LAKE NONA PARCEL 10

SUMMARY

MASTER PLAN ANALYSIS

PROPOSED SITE PLAN

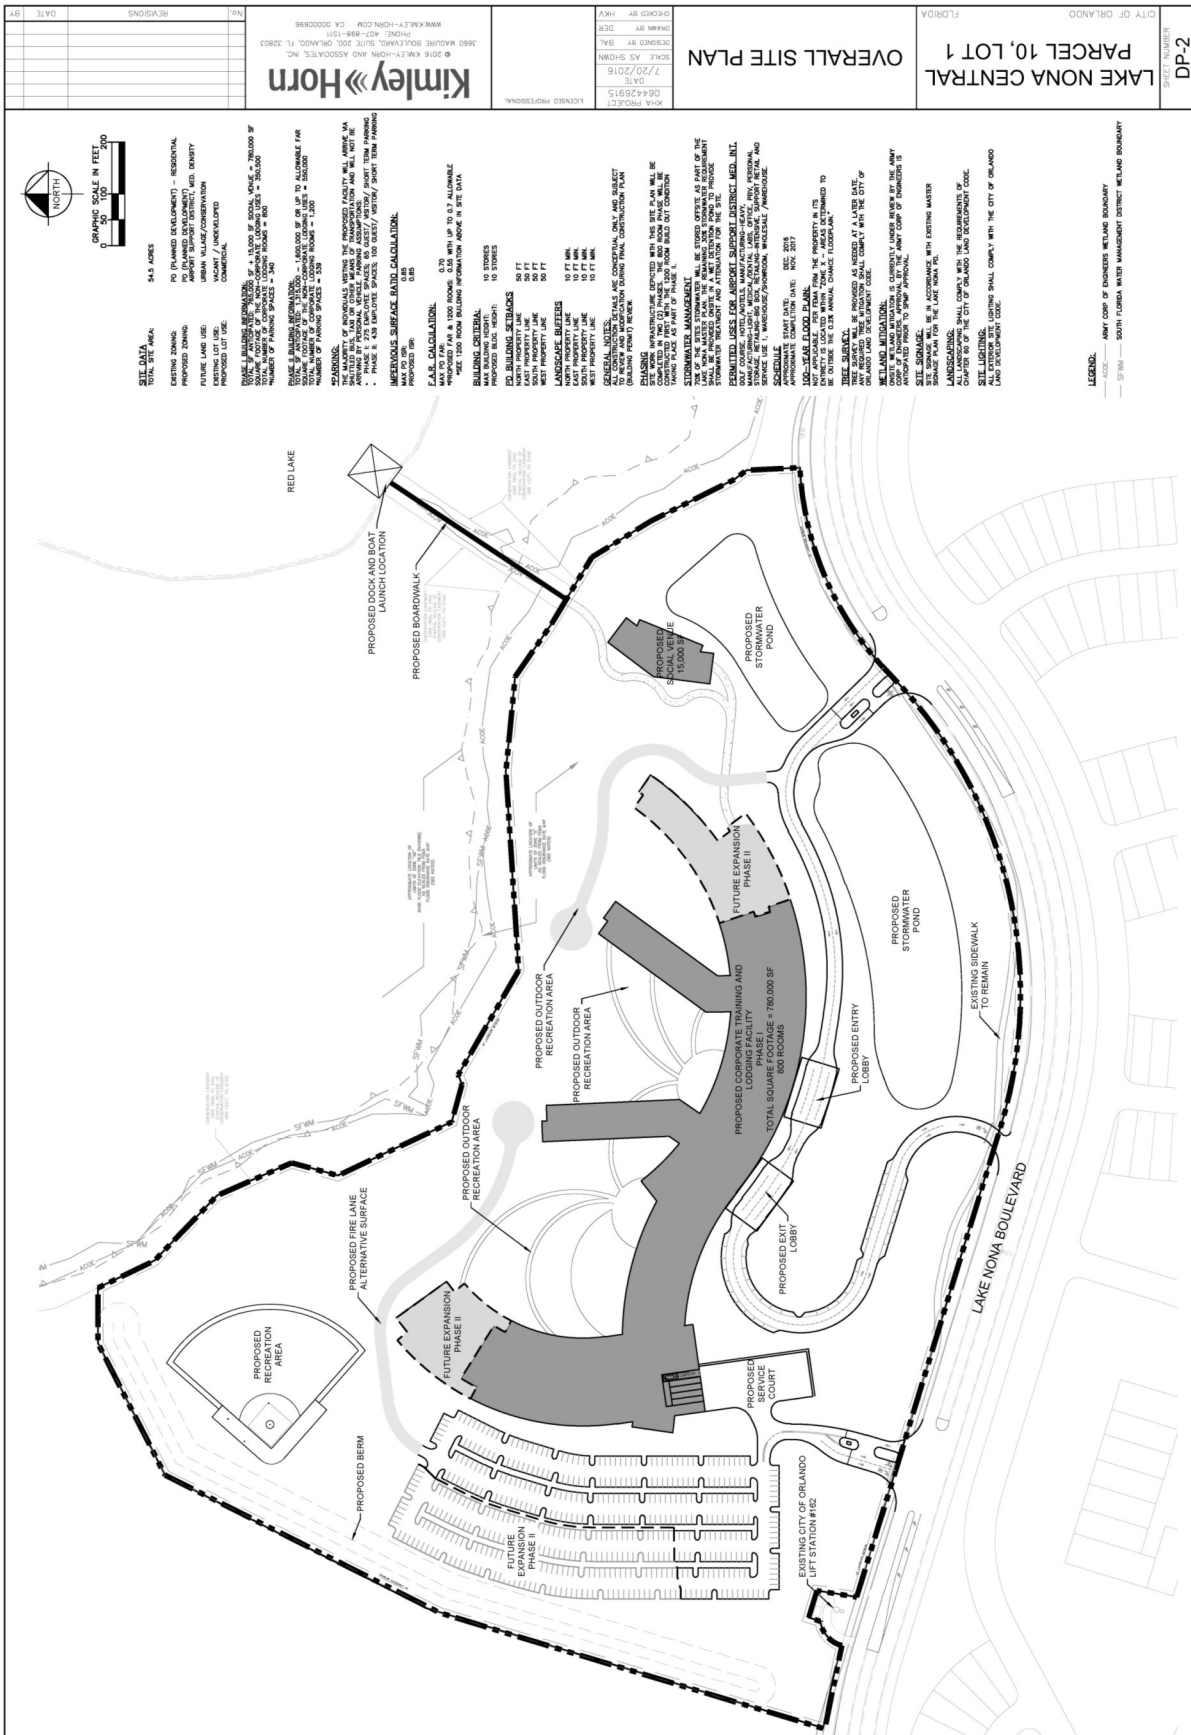
The proposed site plan does not display sidewalks and bike paths, however, sidewalks and bike paths are required connecting to

Lake Nona Boulevard at all of the project entrances and exits. The site plan must be amended and submitted with the Appearance Review application to display the sidewalks and bike paths.

PROPOSED LANDSCAPE PLAN

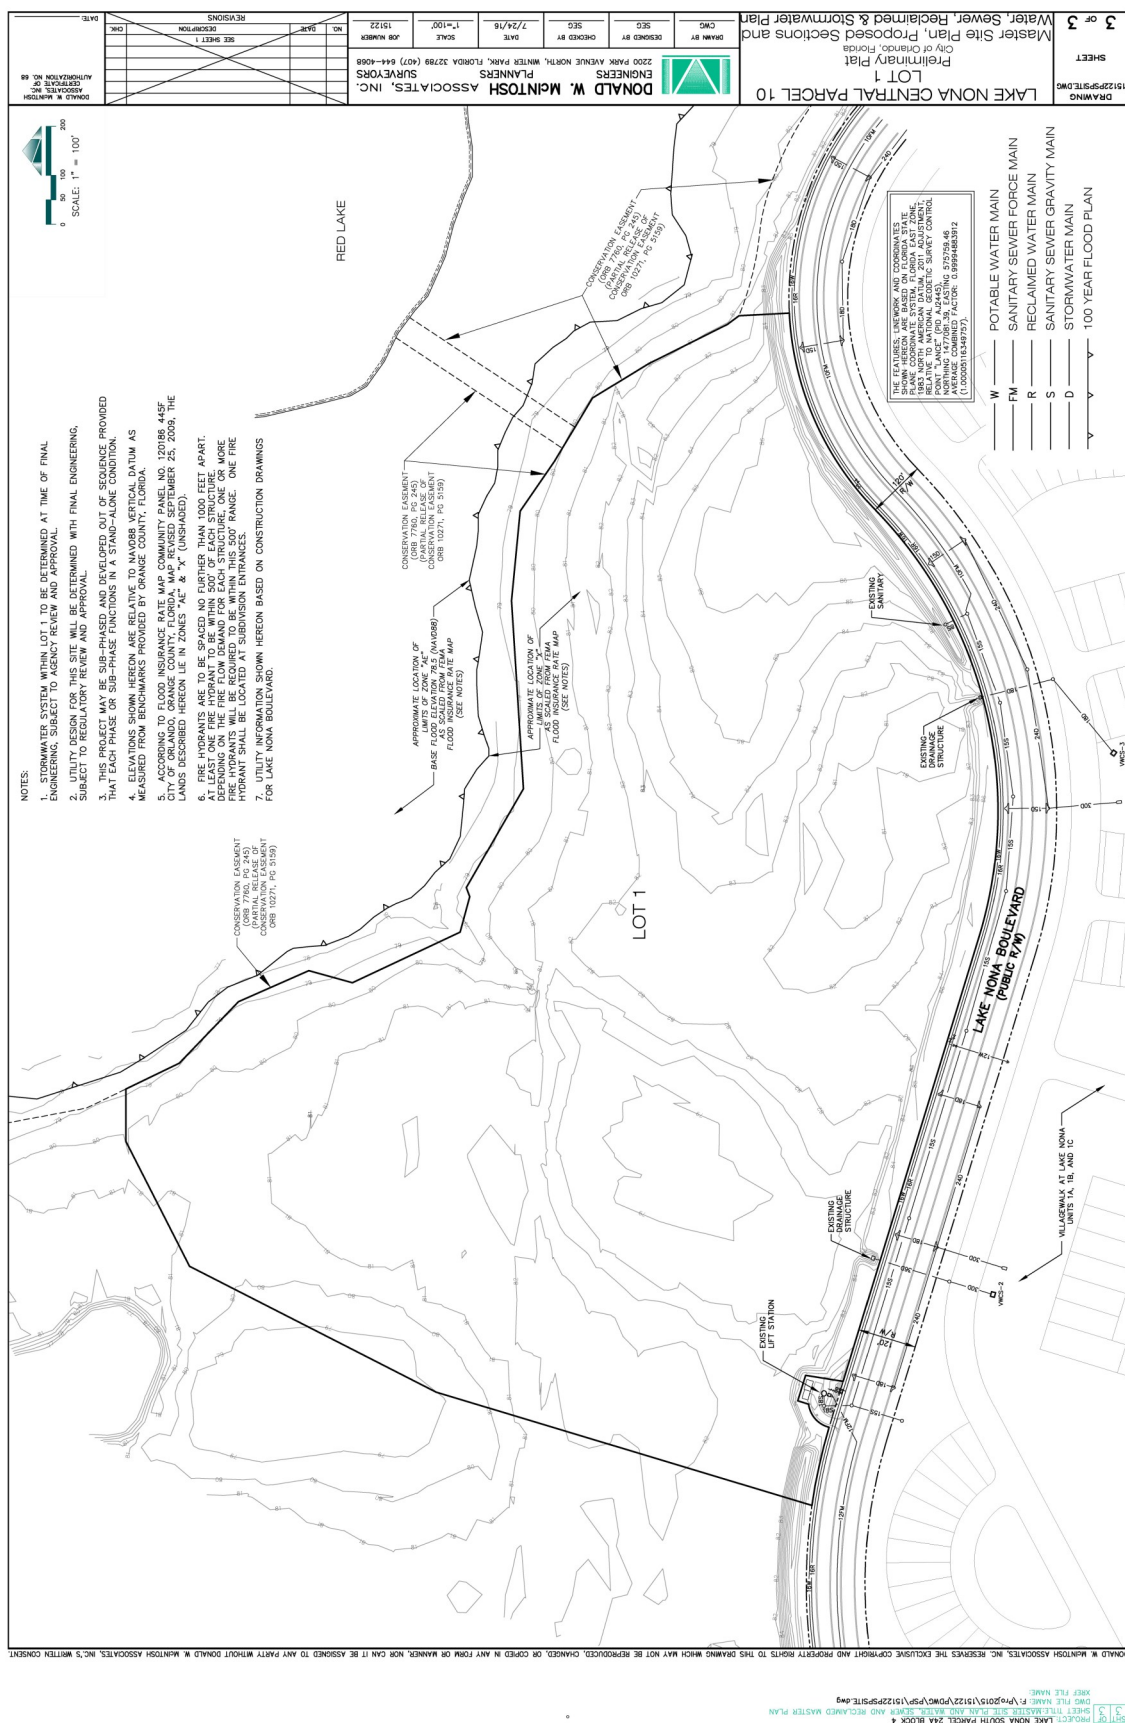
A draft landscaping plan was submitted as part of this application. A bufferyard B is required between the proposed use and the residential single family to the south. The final site plan, to be submitted with the appearance review application, should have some areas with thicker landscape buffers adjacent to Lake Nona Boulevard, while allowing for areas with less landscaping to allow for some views into the site. The loading dock and dumpster area is located in front of the front façade. The loading dock area must be surrounded by a wall that screens the trucks as well as a thick landscape buffer, as depicted on the draft landscape plan.
